**HISTORIC AND DESIGN REVIEW COMMISSION**  
**June 29, 2022**

**HDRC CASE NO:** 2022-329  
**ADDRESS:** 227 W GRAMERCY  
**LEGAL DESCRIPTION:** NCB 3970 BLK D LOT 29  
**ZONING:** R-5, H  
**CITY COUNCIL DIST.:** 1  
**HIST. DIST. NAME:** Monte Vista  
**APPLICANT:** Darian Mason/Peli and Mason Architecture Shop  
**OWNER:** Aaron Prado/ PRADO AARON ELLINGTON & LOREN ELAINE  
**TYPE OF WORK:** Partial demolition (primary and accessory), construction of two-story additions (primary and accessory)  
**APPLICATION RECEIVED:** June 6, 2022  
**60-DAY REVIEW:** Not applicable due to City Council Emergency Orders  
**CASE MANAGER:** Jessica Anderson

**Historic and Design Review Commission**  
***Design Review Committee Report***

sheet title  
**Site Plan**

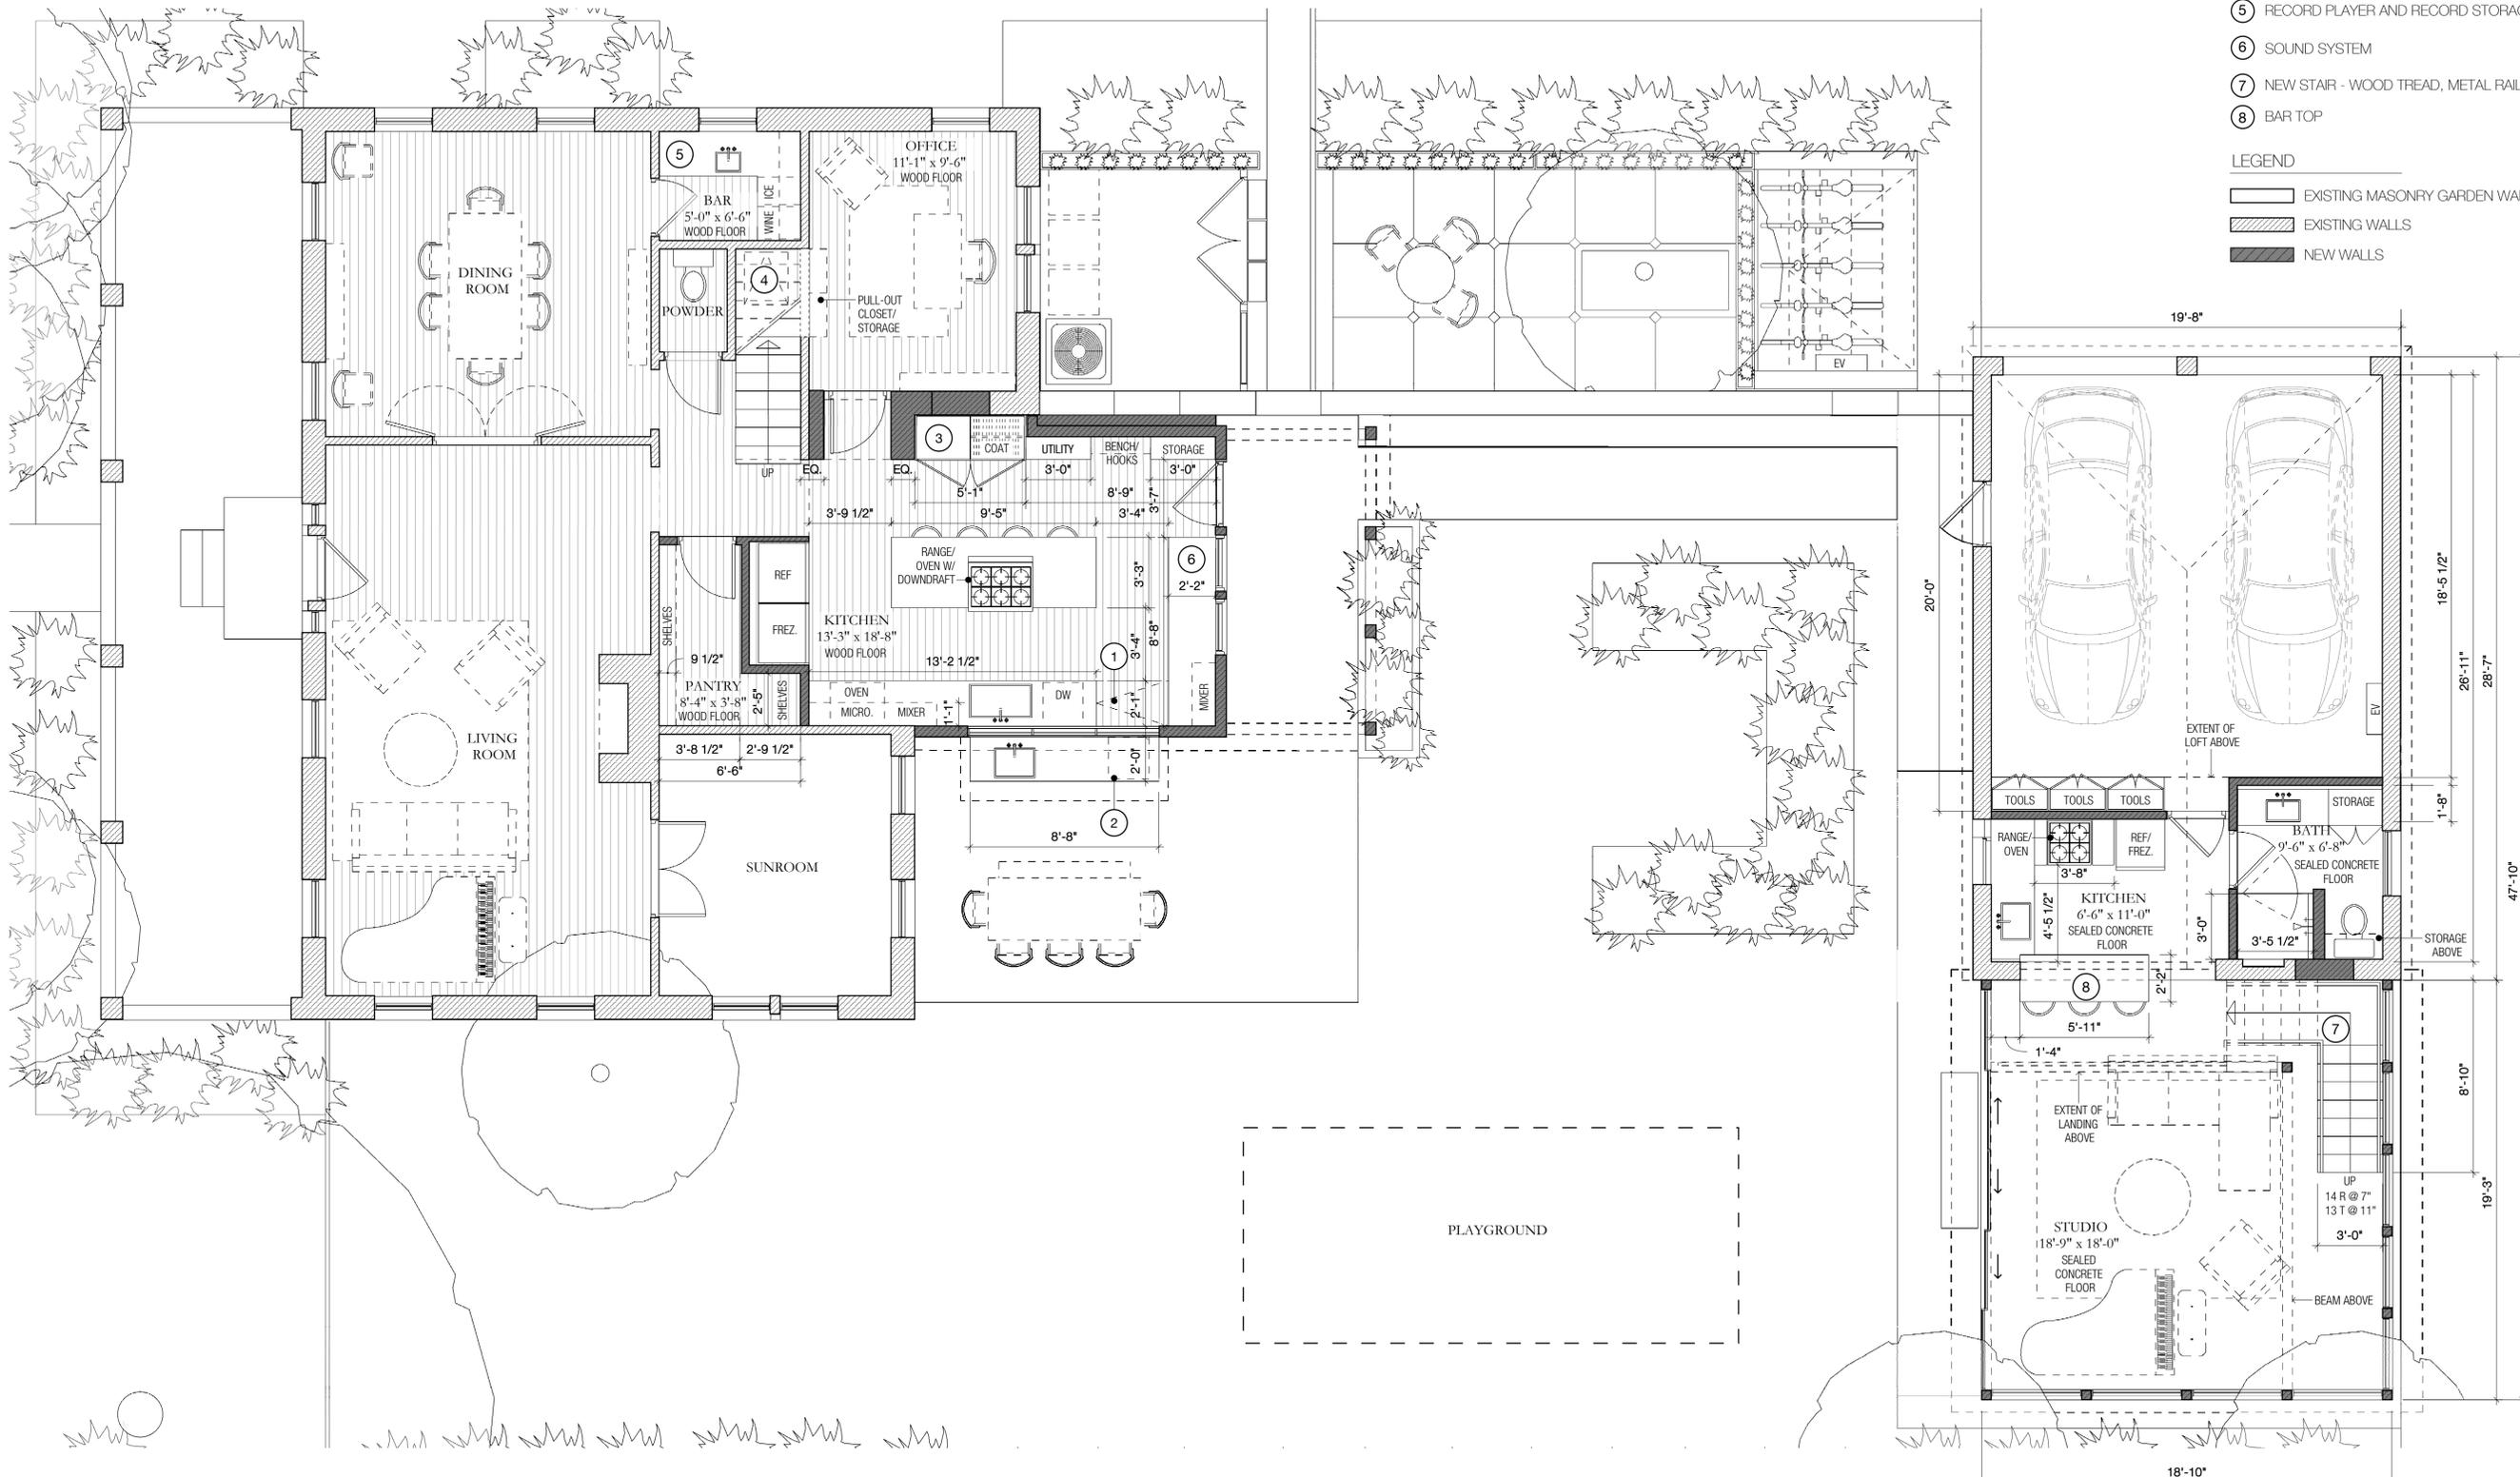
- i. **TERRACE AND GARDEN WALL:** The applicant requests conceptual approval to install a permeable terrace and low garden wall between the existing brick wall and the right-of-way on the east side of the parcel. The applicant does not specify materials for the garden wall. Staff finds the proposed terrace and garden wall are consistent with guidelines.

- i. That the applicant submit measured drawings of the proposed terrace and garden wall prior to final approval.

**1** NORTH SITE ELEVATION - MAIN HOUSE

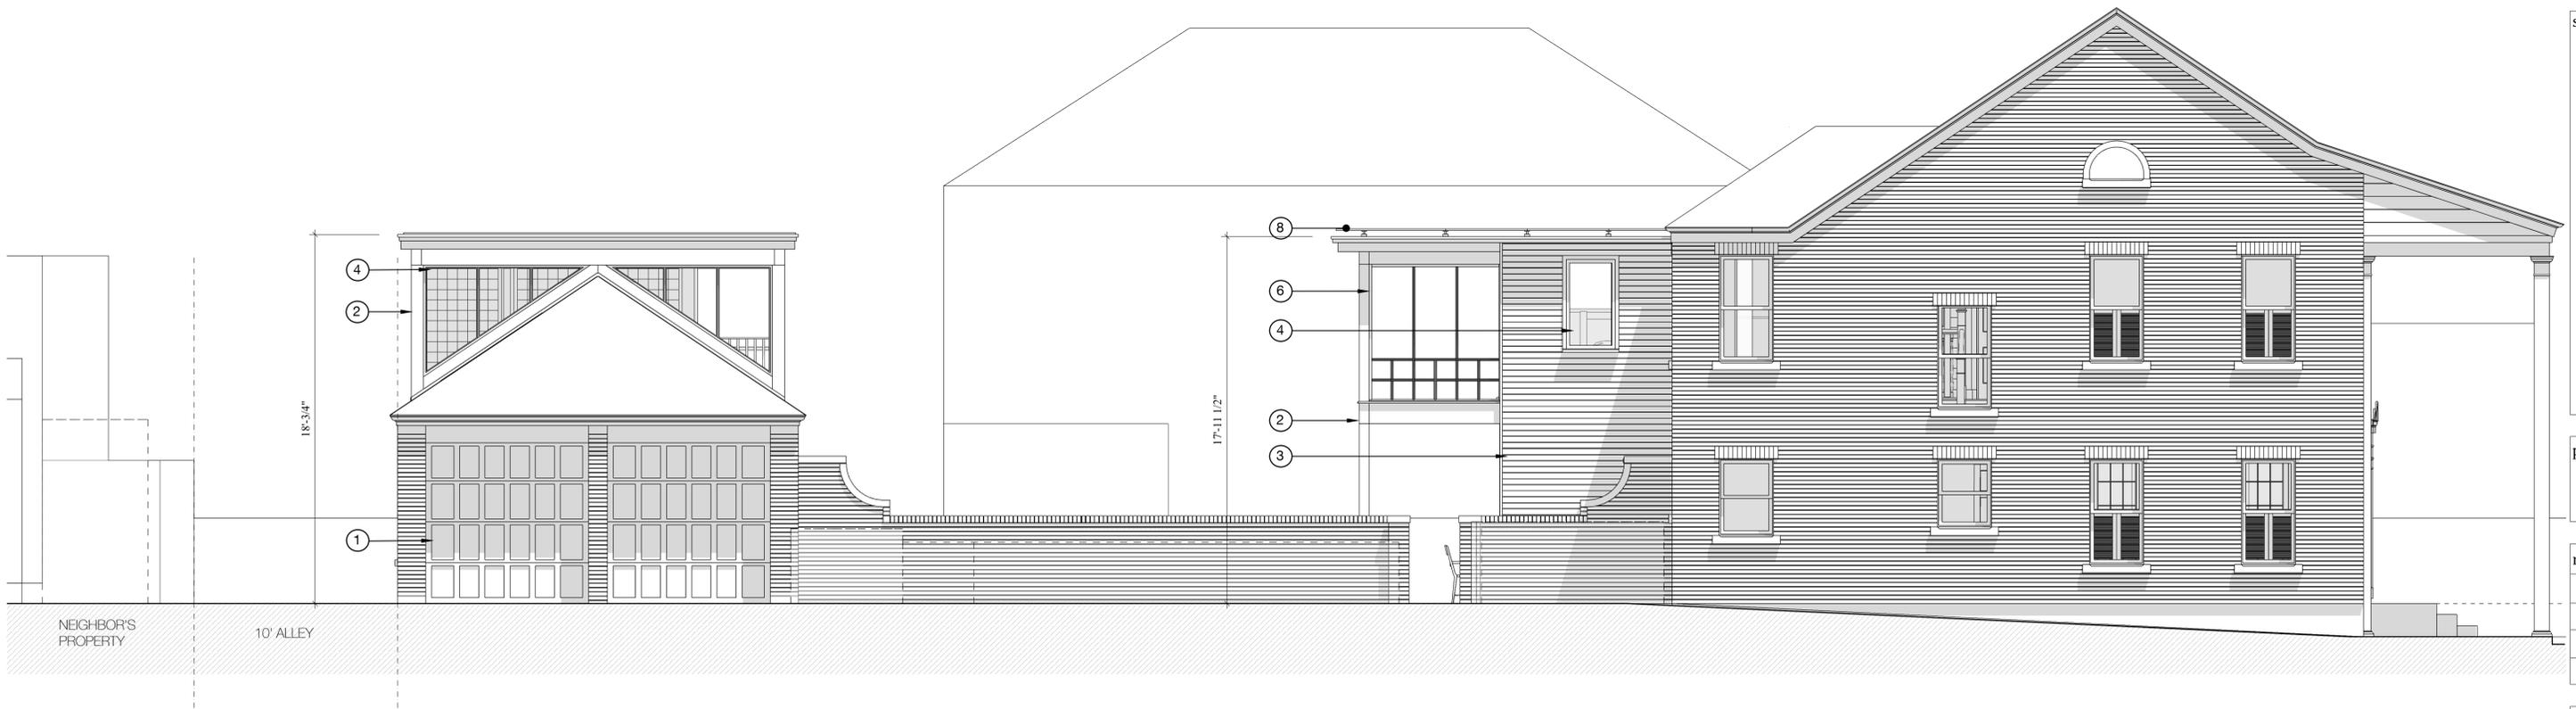
- e. **WINDOWS (PRIMARY ADDITION):** The applicant proposes fixed aluminum clad windows with transoms on the north and east elevations and fixed windows on the second floor of the east elevation. Windows on the house are one-over-one wood windows of equal sash size. Per Standard Specifications for Windows in Additions and New Construction, new windows on additions should relate to the windows of the primary historic structure in terms of materiality and overall appearance. Windows used in new construction should be similar in appearance to those commonly found within the district in terms of size, profile, and configuration. Staff finds the proposed window profiles on the north and east elevations are not consistent with these specifications. The window proposed on the west side of the addition is consistent with these specifications.

- i. That should the applicant choose Hardi board, it be installed with a 4” reveal, smooth side out.
- ii. That the applicant propose windows for the north and east elevations that conform to Standard Specifications for Windows in Additions and New Construction, specifically the windows on the second story of the north elevation.

sheet title  
**Site Elevations - Garage**

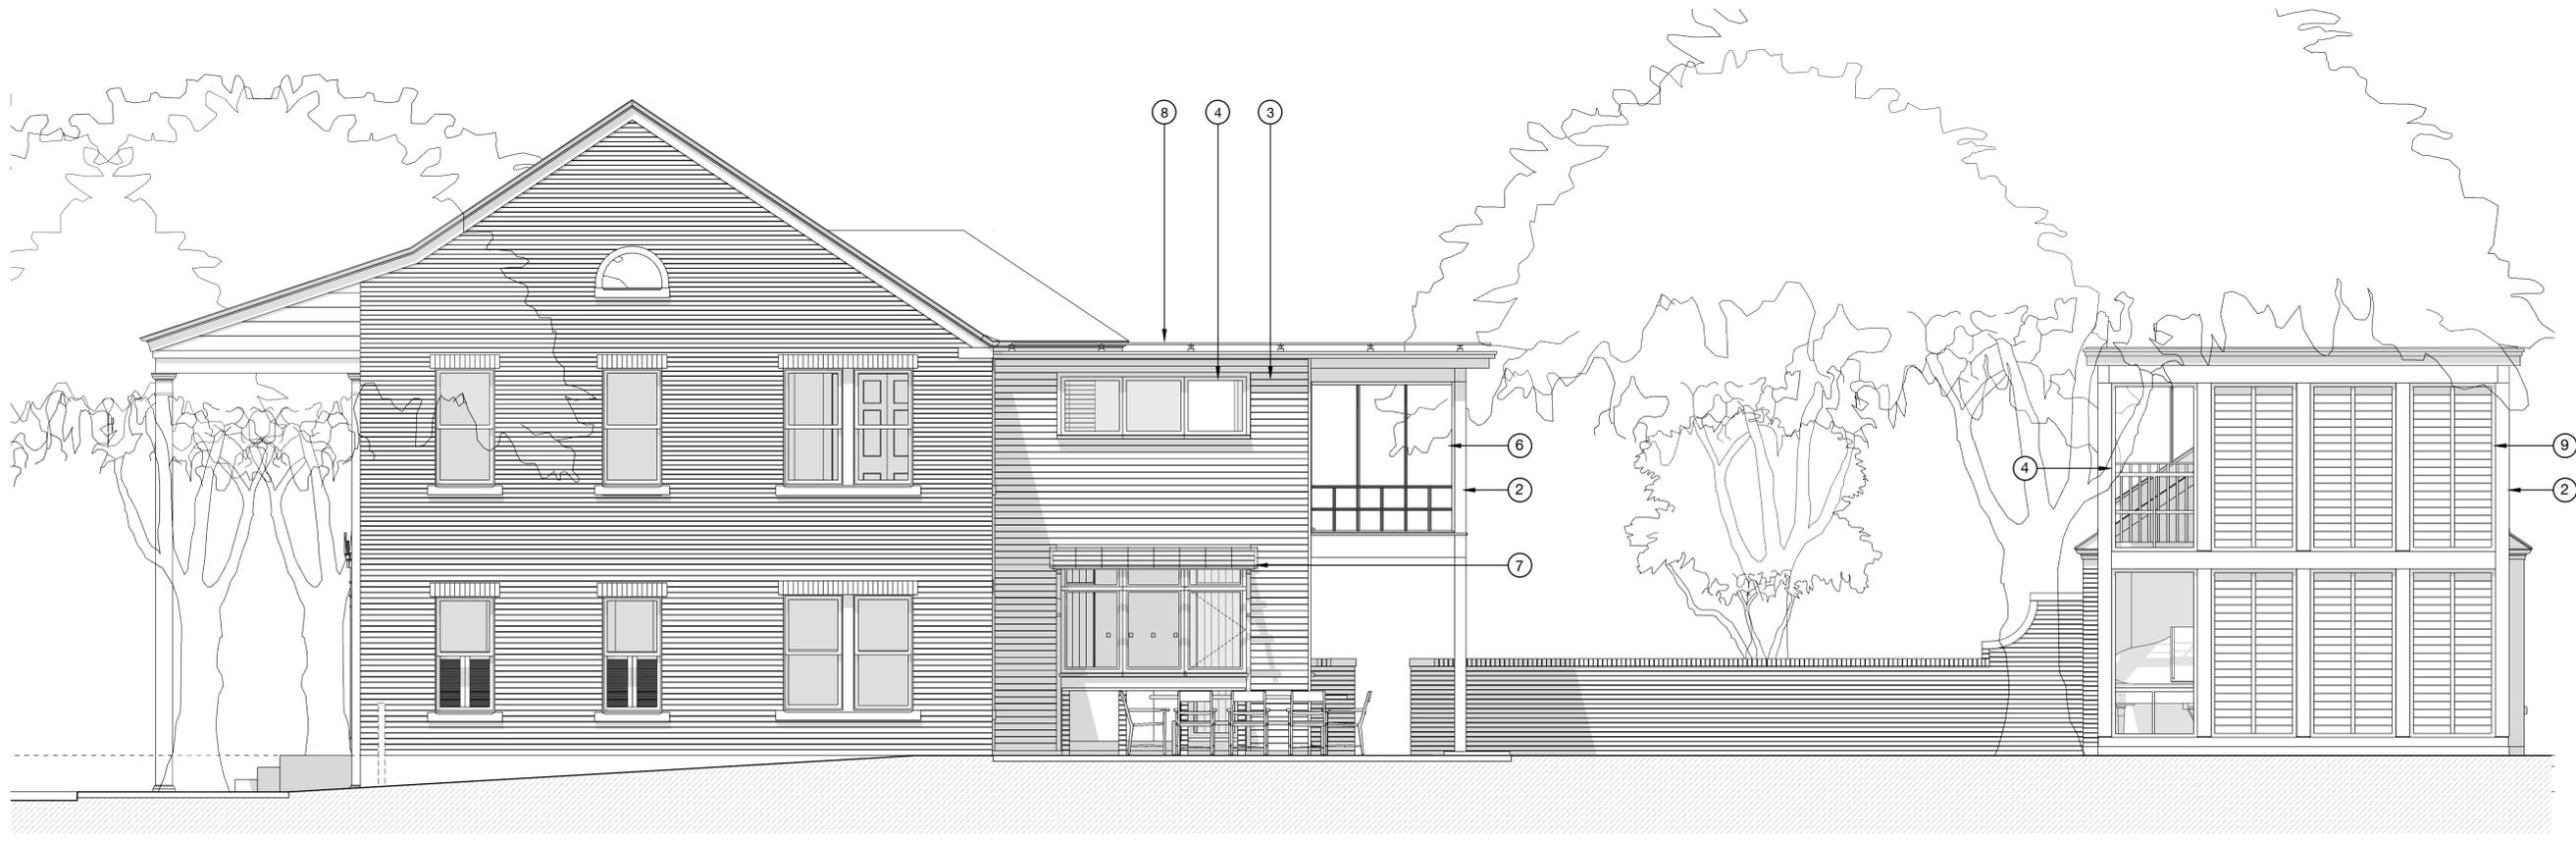
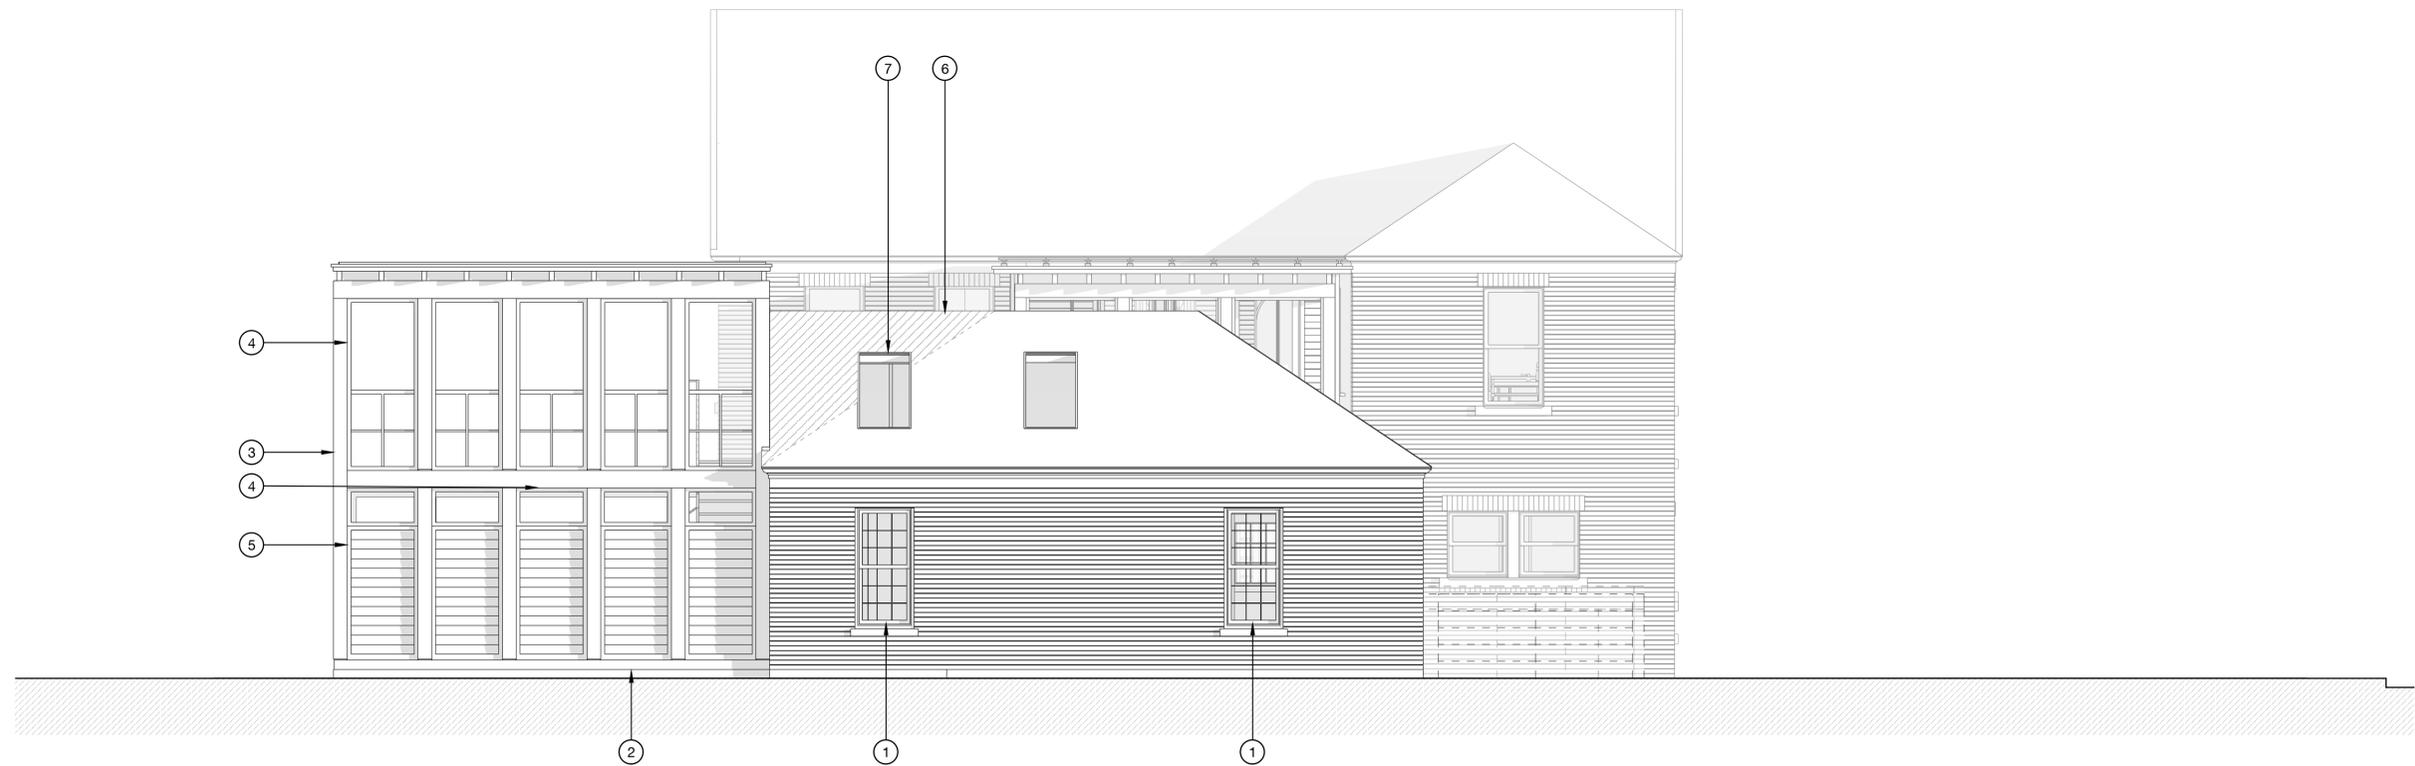
- h. **WINDOWS (GARAGE ADDITION):** The applicant proposes full-height one-over-four aluminum clad windows on the second floor of the garage addition. Windows on the house are one-over-one wood windows of equal sash size. Per Standard Specifications for Windows in Additions and New Construction, new windows on additions should relate to the windows of the primary historic structure in terms of materiality and overall appearance. Windows used in new construction should be similar in appearance to those commonly found within the district in terms of size, profile, and configuration. Staff finds the proposed window profiles on garage addition are not consistent with these specifications.

- Commissioner Savino expressed concern about the mass and flat roof of the proposed accessory addition. Felt the addition is noticeably taller than existing garage. Commissioner Fetzer suggested expanding elevations to include adjacent structures to give context to proposed height of garage addition.
- Commissioner Fetzer expressed concern about relative roof heights of the proposed additions. Mason shared that the garage addition is taller because height of the primary addition was informed by existing plate height.
- Commissioner Fetzer expressed concern about roof fascia detailing on primary addition vs garage addition and suggested the applicant explore making primary addition details more prominent or at least as prominent as those found on the proposed garage addition.

- i. That the applicant propose windows that conform to Standard Specifications for Windows in Additions and New Construction.
